Dose Assessment Topics (Identified by PAB)

NRC Comment (PAB 1): Additional information is required to evaluate the dose contribution from the Insignificant Radionuclides given the uncertainty in mixture percentages.

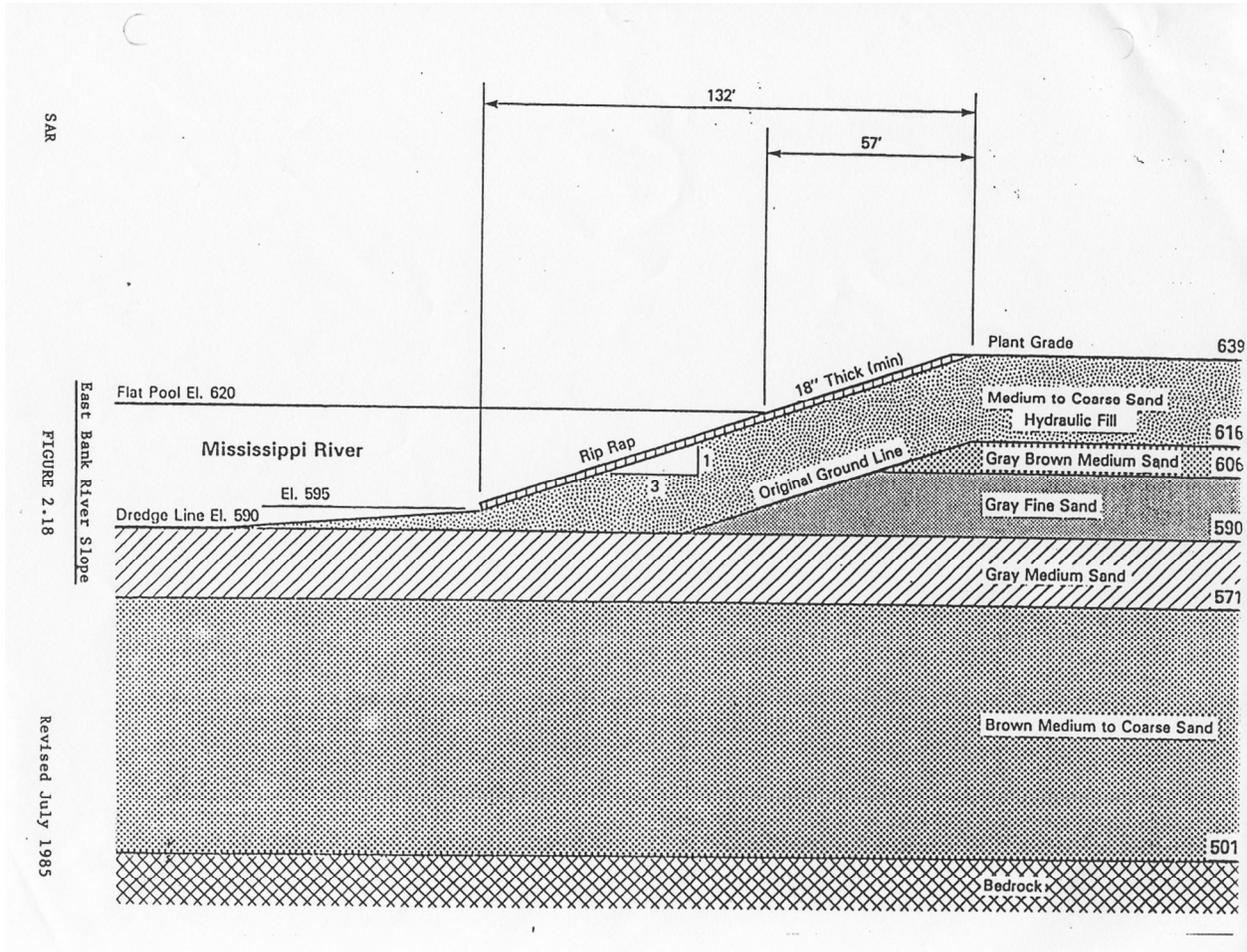
Provide information on the design and design criteria for the embankment and rip-rap that protects the hydraulic fill used to elevate the site to 639 foot MSL.

The site elevation is above the recorded river stage levels; however, the 1965 recorded flood stage and the estimated 100-year flood stage are within 1.8 feet of the site elevation. In addition, the upstream and adjacent configuration of the Mississippi River indicates that the possibility of cut-bank erosion along the site cannot be discounted, especially during flood events near the site. Finally, there is no information provided on the capability of the embankment and rip-rap to withstand cut-bank erosion during high river flow periods over the 1000-year performance period of the embankment, or the 200-year design period.

LACBWR Response (HYDRO-2): The 639 foot MSL elevation was selected on the basis of the calculated 100-year flood, which would reach an elevation of 635.2 feet MSL with a flow of 220,000 cfs. The highest floods on record did not reach 639 feet MSL, although flows in excess of 220,000 cfs have been recorded.

Figure 1 – Well Locations and Groundwater Gradients within the Shallow Aquifer (December 2016)

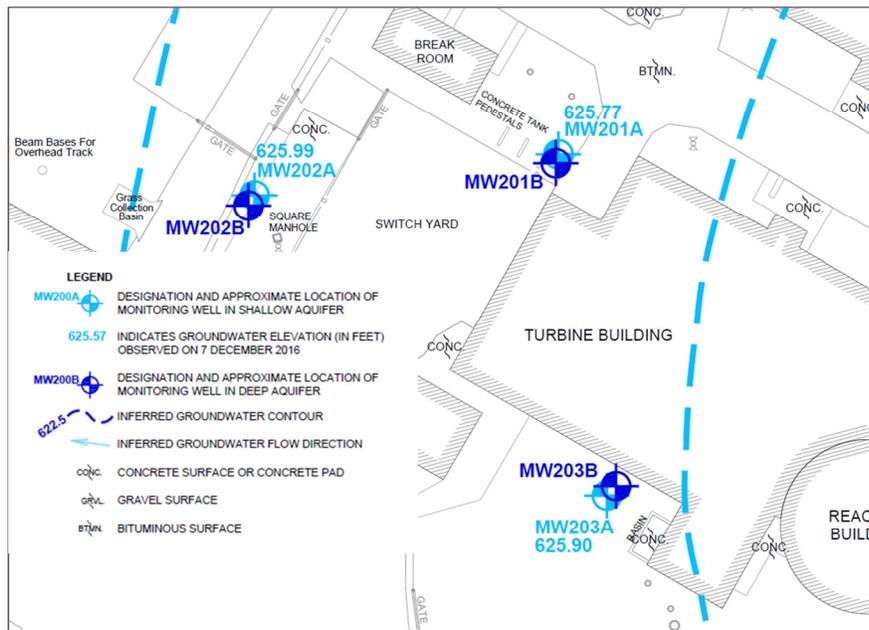
locations of these wells, as well as the potentiometric surface of the shallow aquifer, are shown on Figure 1. It should also be noted that the LTP states that the MW-203 pair was installed up-gradient of the piezometer location, but it did not note that the well pair was installed down-gradient of the Turbine Building and the potential floor drain leaks.

The 2015 Characterization Survey Report (LC-RS-PN-164017-001) was previously submitted to the NRC on July 26, 2016. The FSS Plan (L1-SUB-TDS) for survey unit L1-010-102 will be submitted to the NRC for information. The accompanying data will be submitted to the NRC for evaluation.
